Office Action Summary

10/602,930

HARTLEY ET AL.

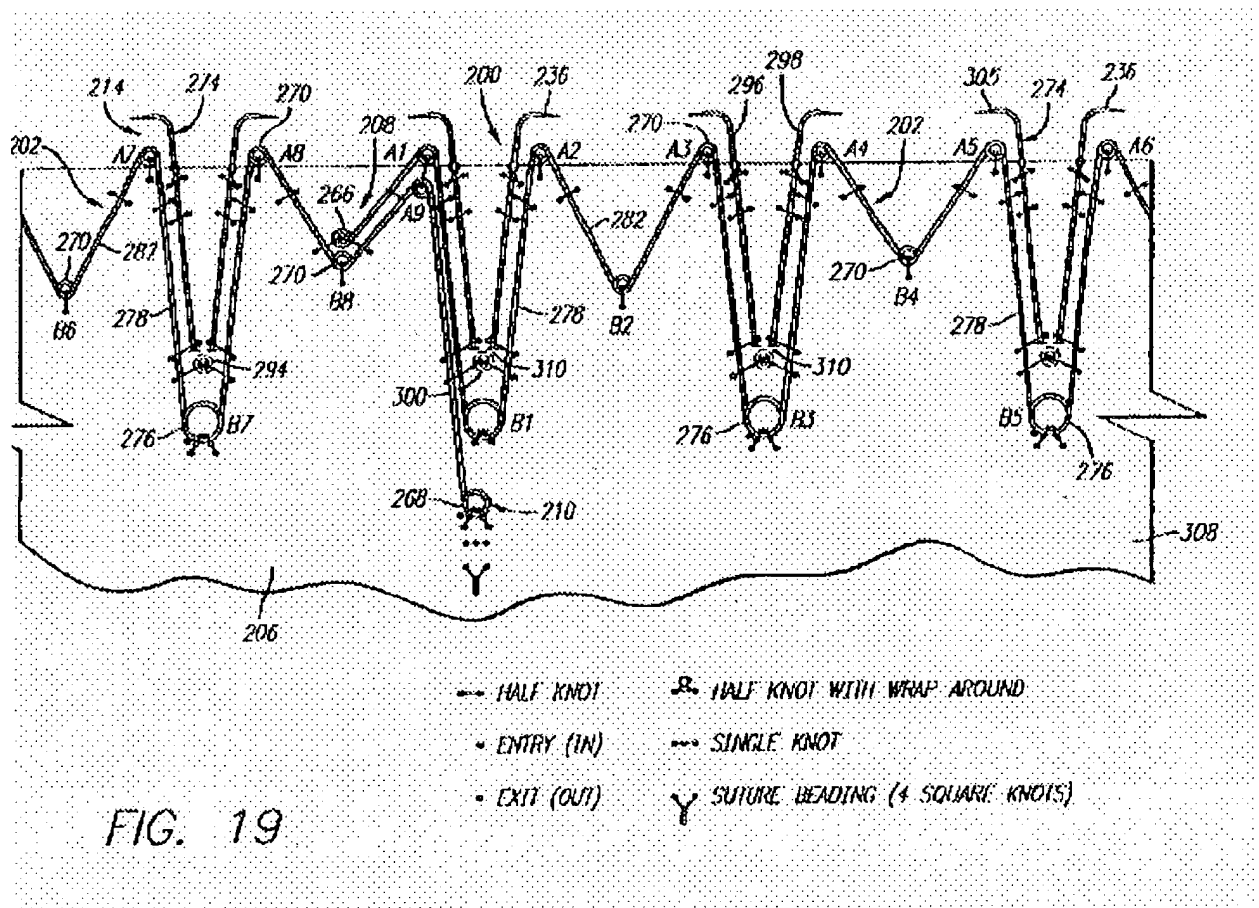
Claims 1-3,5-9,22 and 23 are rejected under 35 U.S.C. 102(e) as being anticipated by Baker et al (6814748).

Baker et al discloses a 1 medical device comprising: a graft material, stent affixed to and extending from the graft material, the stent comprising plurality of struts and bends between them, the bends defining apices, and at least two spaced apart fastenings affixing the stent to the graft material, each fastening including at least one turn of an elongate flexible fibre through the graft material and around a portion of the stent wherein a first of the at least two spaced apart fastenings is laced at the apex and a second of the at least two spaced apart fastenings is laced adjacent the transition from the bend to the strut. See figure 19.

arrangements, including single, square and half knots. Claim 5, see column 19, lines 14+. Claim 6, see column 23, lines 4+. Claim 7, see column 10, lines 5+. Claim 8, see column 7, lines 1+. Claim 9, see columns 10 and 11. Claims 22, the manner by which the stitches are placed on the graft does not impart further structural distinction over the same as disclosed by Baker, et al. Claim 23, see figure 19 supra.
